MAJOR REPAIR AND ALTERATION (Airframe, Powerplant, Propeller, or Appliance)

1. Aircraft	Make Republic	Model RC-3
	Serial No. 1000	Nationality and Registration Mark N5166B
2. Owner	Name (As shown on registration certificate) Davey Darrell L Davey Deborah A	
	Address (As shown on registration certificate) 6613 Santa Rosa Rd Camarillo Ca 93012-5672

Republic RC-3 N5166B Ser.# 1000

2. Description: Modified elevator trim control by removing original trim control from top of cabin to instrument panel. Installed Cessna P/N 0510127-2 Wheel, tab control and Cessna P/N 0432134-1 Sprocket, tab control on .250" 303 stainless steel shaft with roll pins, Cessna P/N NAS561P3-4, mounted with Torrington bearings, Cessna P/N M-451 (2ea.), in brackets fabricated from .250" 6061 T6 aluminum plate and secured to instrument panel with MS24693C screws. Trim position indicator fabricated from 1/16" welding rod and attached to trim wheel position follower fabricated from .040 2024 T3 aluminum sheet. Position indicator is held in place with groove cut in avionics mounting support. Trim control cable, 1/16" stainless flexible control cable conforming to MIL-W-83420, is attached to trim control chain, Cessn

Elevator Trim

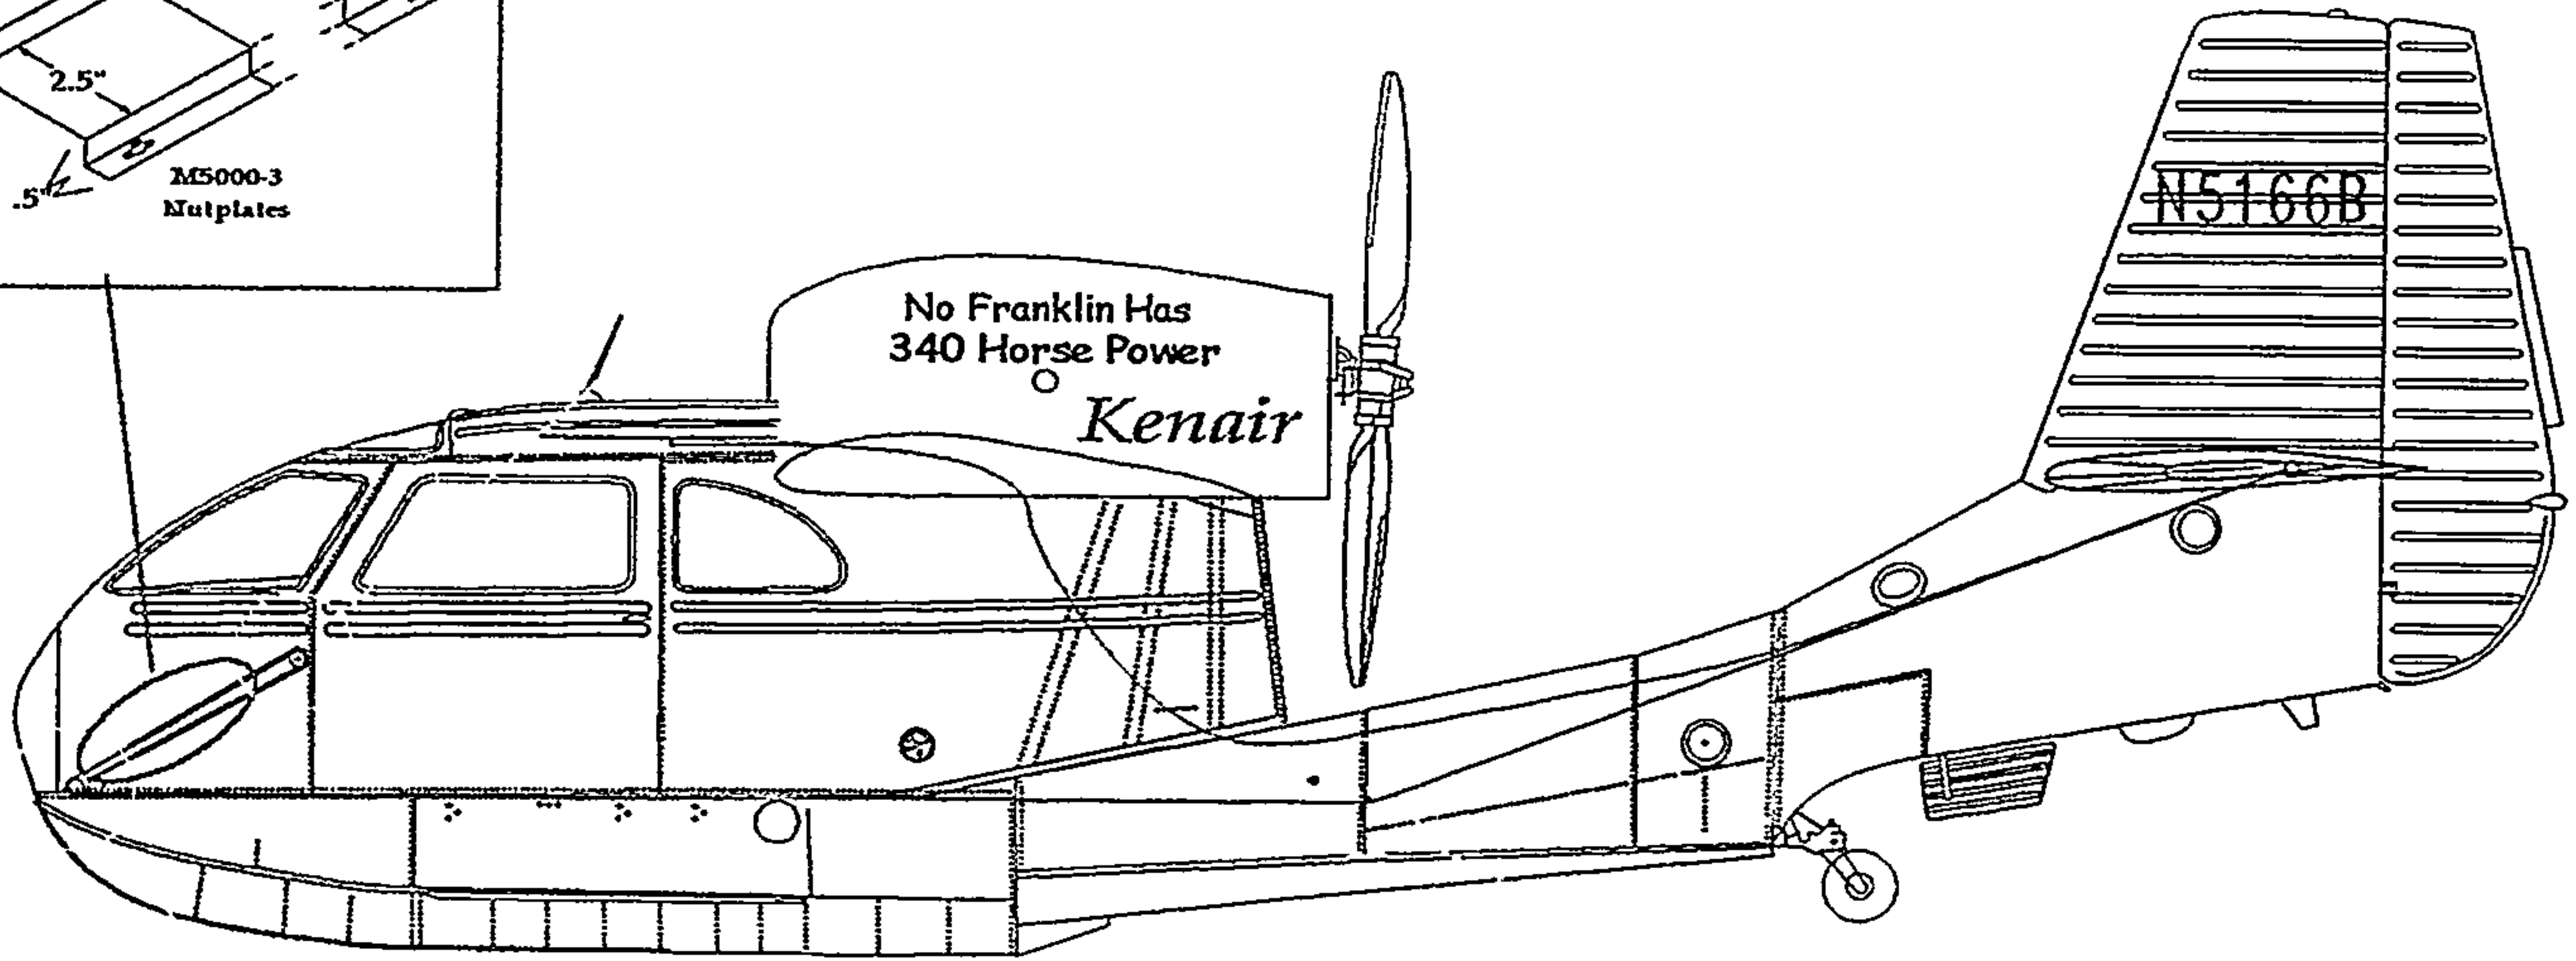
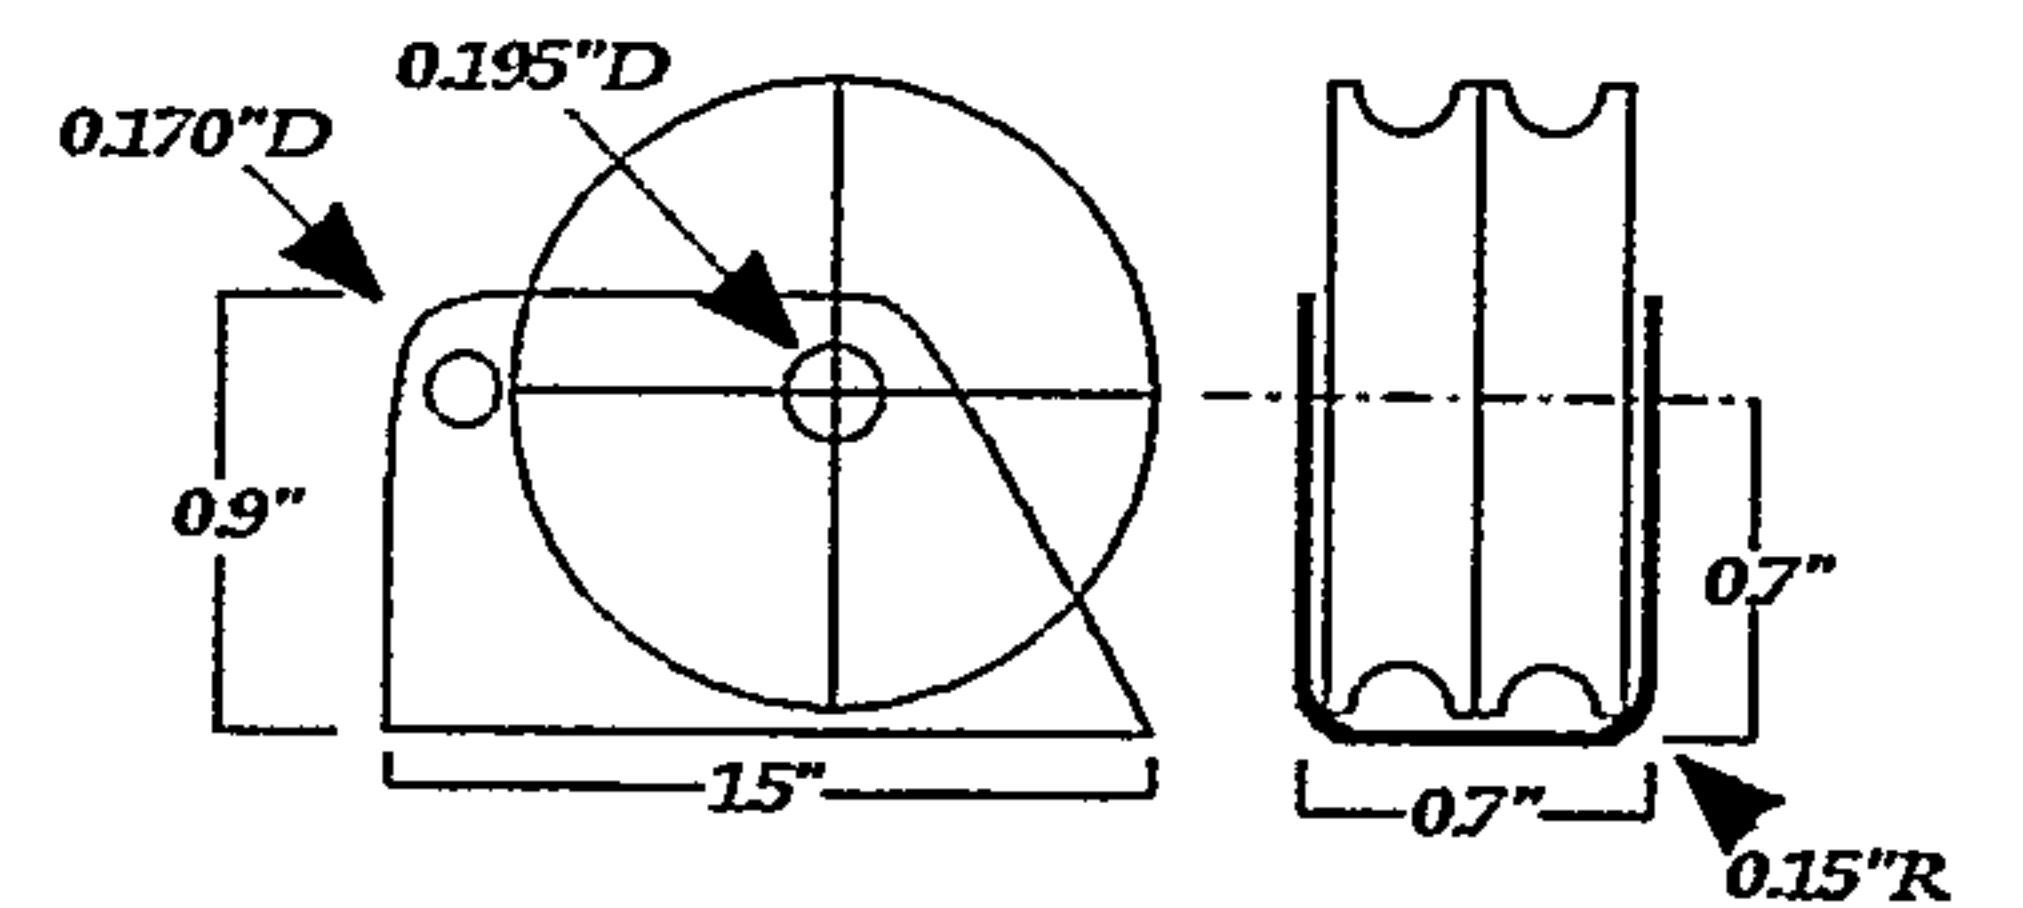
Blue - Original Routing of Trim Control
 Red - Modified Trim Control Routing
